Fort Lauderdale Police Headquarters Project Update

September 3, 2025

Phase 2 - Summary

Fort Lauderdale Police Headquarters Project Status Exhibit 3

North Elevation Structural Rectifications

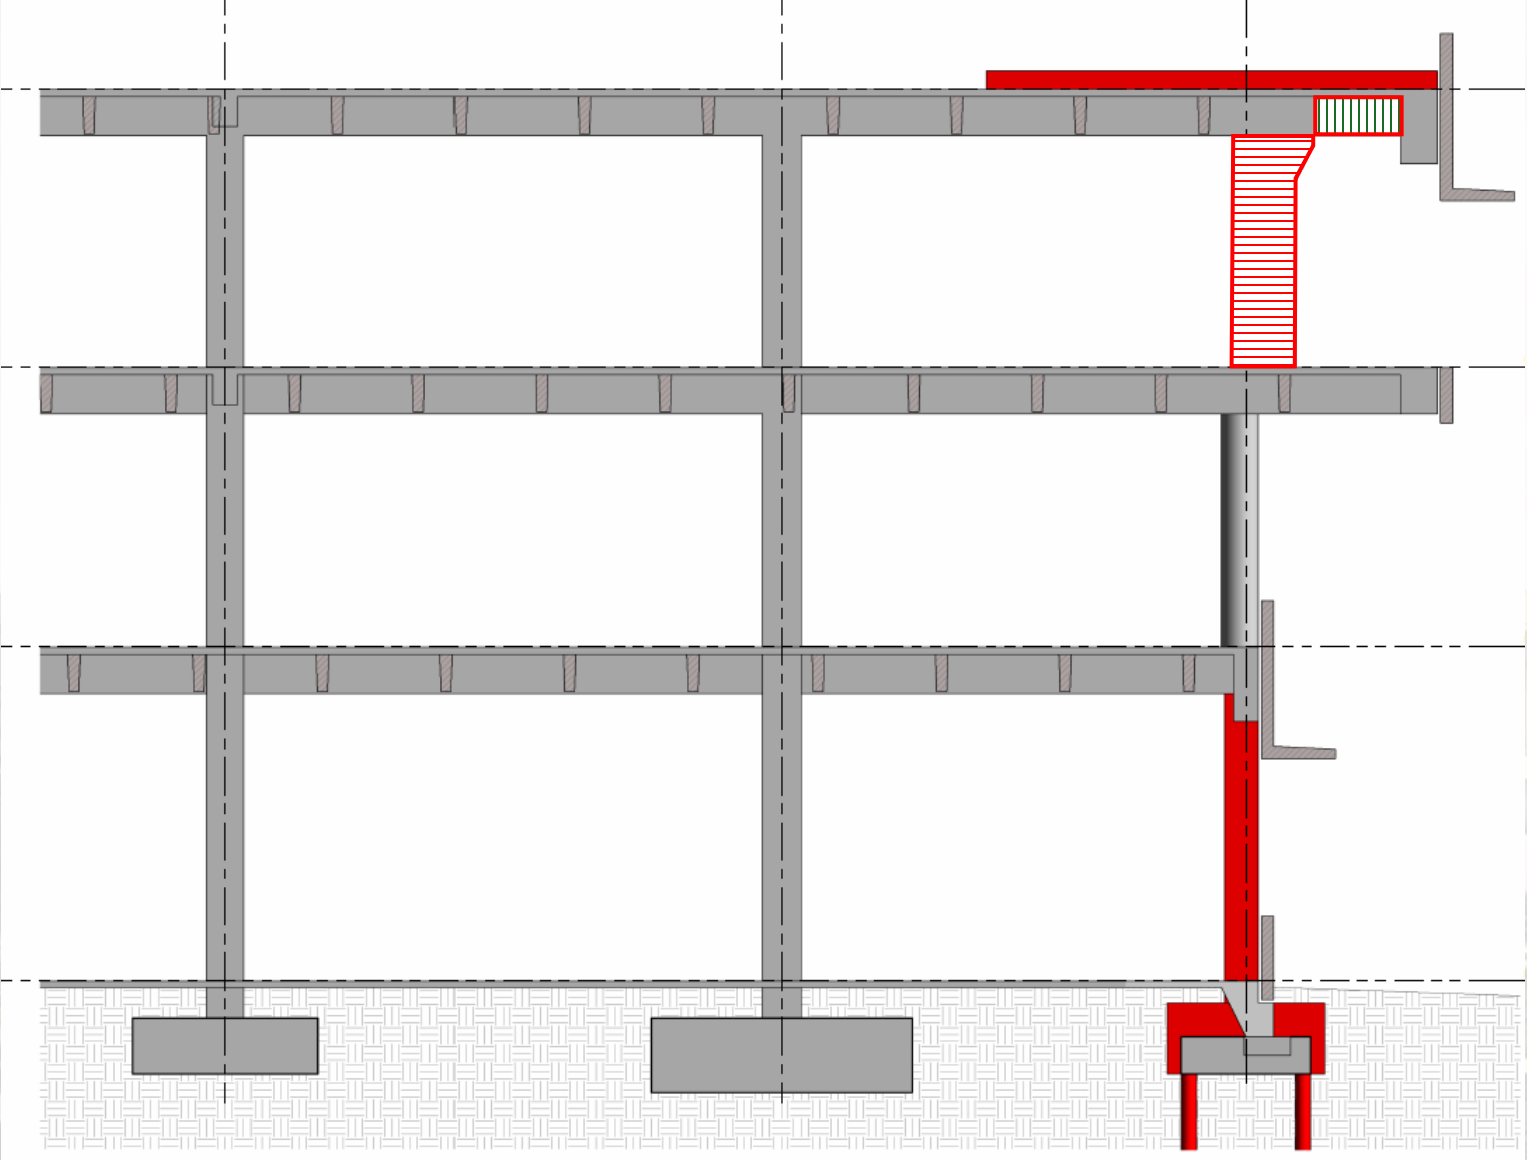
- 1st Story Foundation
 - Micropile Installation & Caps (Complete)
 - Epoxy Injection (Complete)
 - Interior Slab Restoration (Complete)
- 1st Story Columns
 - Column Jackets (Complete)
- 3rd Story Columns/Cantilever Beams
 - Column Enhancement (Complete)
 - Fiber-Reinforced Polymer (Work Commencing)
- Roof
 - Up-Turn Cantilever Beams (Complete)
- Draft 1st Amendment AECOM Agreement
 - Draft Sent to AECOM on May 6, 2025
